UNITED STATES PATENT AND TRADEMARK OFFICE

10/582,735

Office Action Summary	Application No. 10/582,735	Applicant(s) POWERS ET AL.	
	Examiner BRANDON M. ROSATI	Art Unit 3744

DETAILED ACTION

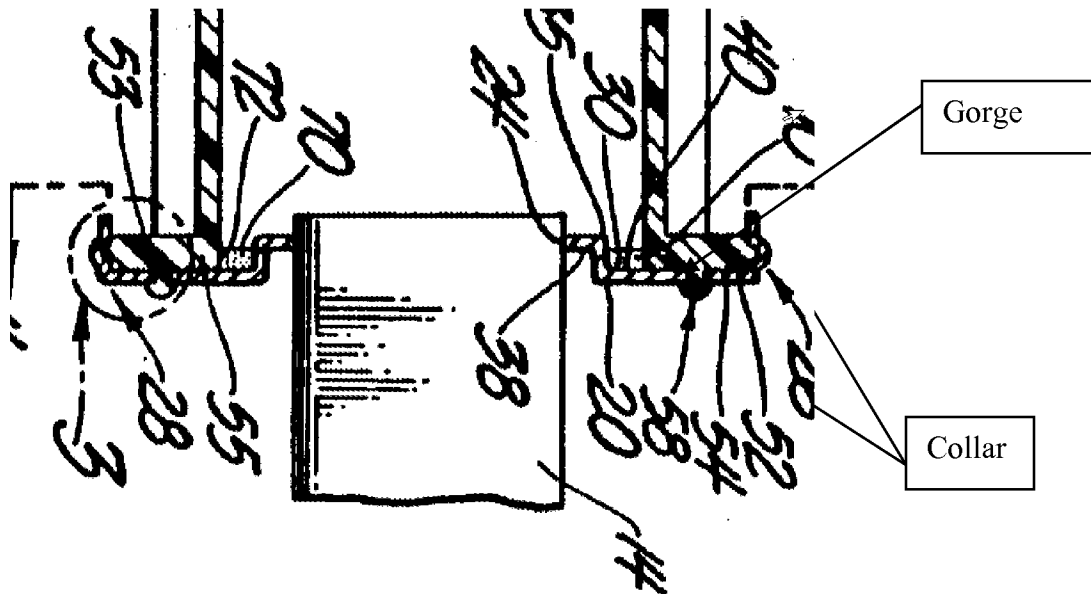
Regarding claim 10, Puntambekar et al. disclose in Figures 1-3, a heat exchanger body part, a heat exchanger tank part (i.e. tank unit) (12), a header (20), a tube (14) extending from the heat exchanger body part and passing through a slot provided in the header pan, the header pan disposed at an end of the tube, the header pan defining a collar (as seen in the Figure below) forming a tube ferrule, a tank foot at the end of the tank (i.e. parallel arms) (50 and 51), a gasket (i.e. adhesive material) (70), wherein the header pan is flat and the tube forms a gorge, wherein the gasket and tank foot are received (Column 2, lines 23-55 and Column 3, lines 11-21). It is noted that although Puntambekar et al. does not specifically disclose the term a gasket, the adhesive as disclosed performs the same function as a gasket. It is further noted that the Examiner is interpreting the collar to be the area as indicated in the Figure below. It is also noted

Regarding claim 13, Puntambekar et al. disclose the collar (as shown in the Figure above) inverted in relation to the line of extension of the tube.
